Order Instituting Investigation pursuant to Senate Bill 380 to determine the feasibility of minimizing or eliminating the use of the Aliso Canyon natural gas storage facility located in the County of Los Angeles while still maintaining energy and electric reliability for the region.

Investigation 17-02-002  
(Filed February 9, 2017)

**OPENING COMMENTS OF  
CENTER FOR ENERGY EFFICIENCY AND RENEWABLE TECHNOLOGIES ON  
ADMINISTRATIVE LAW JUDGE'S RULING REGARDING MARCH 30, 2021 PHASE 3  
WORKSHOP AND REQUEST FOR COMMENTS**

**Figure 1<sup>4</sup>**

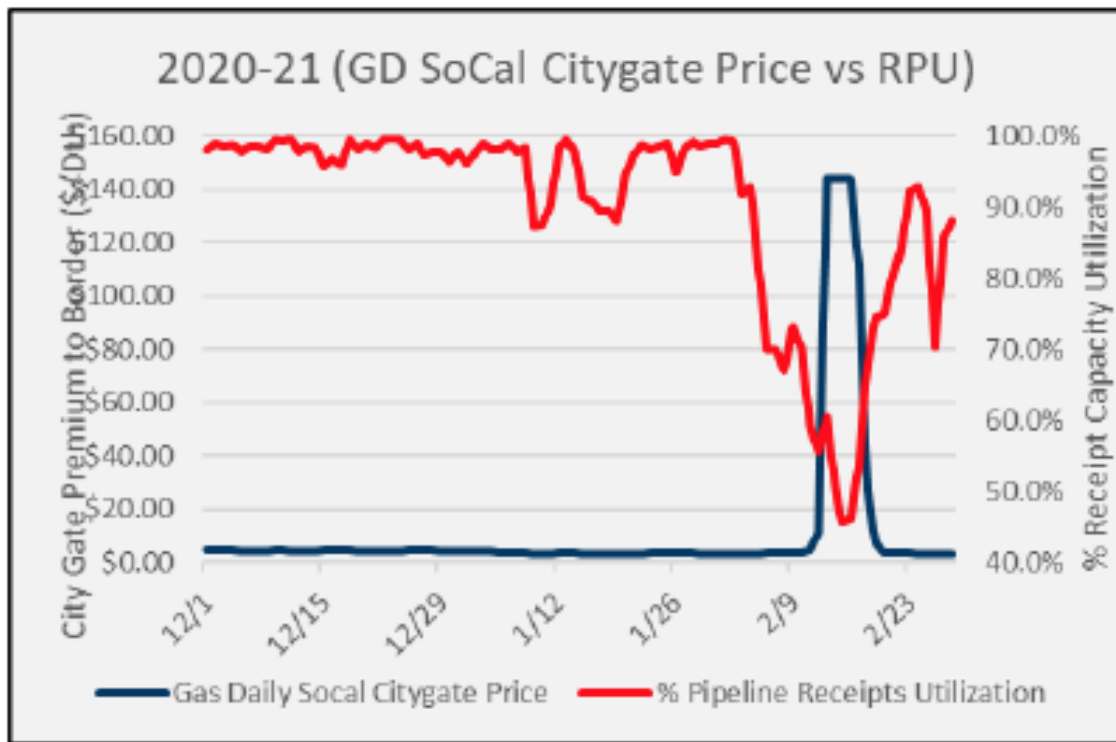
CEERT understands the significance of these findings, but we believe that documentation must be provided before they can be formally entered into the record and used as the basis for Workstream #2. First, a more fulsome analysis of the historic record than simply the latest and greatest example shown in Figure 1 must be presented. Consultants should provide a chart with the full ten year record of the variables shown in Figure 1. Starting about the time of the San Bruno explosion, through the 2011 East Coast polar vortex event, the Aliso Canyon well blowout in 2015, the Line 235 explosion in 2017, and ending with the 2021 Texas polar vortex event, the frequency, severity and variety of contingency events that required Aliso Canyon withdrawals must be documented to support this critical finding. During the March 30 presentation, Commission staff noted that the immediate reaction to the Aliso Canyon well failure was to order maximum withdrawals to lower reservoir pressure and mitigate the size of the well failure leak. This event would show on the ten year record as well. Each such event that significantly impacted City Gate prices and receipt point utilization over the ten year period should be briefly

explained. In addition, two other variables need to be added to the graphic: 1.) Actual Aliso Canyon injections/withdrawals, and 2.) Impact on electricity prices using the California Independent System Operator (CAISO) South of Path (SP) 15 spot price as a proxy for economic impact on electric rates in the LA Basin. CEERT notes that the actual impact of burner tip natural gas price volatility and/or curtailments on electric rates would be masked by other cost factors, hedging strategies, and smoothing effects of the Energy Resource Recovery Account (ERRA) that passes gas costs into electric rates. An important option for public acceptance of the results would be to also document a ten year running record of Southern California Edison (SCE) and Los Angeles Department of Water and Power (LADWP) system average consumer rates; however, these added variables would not directly impact the Phase 3 Workstream #2 analysis.
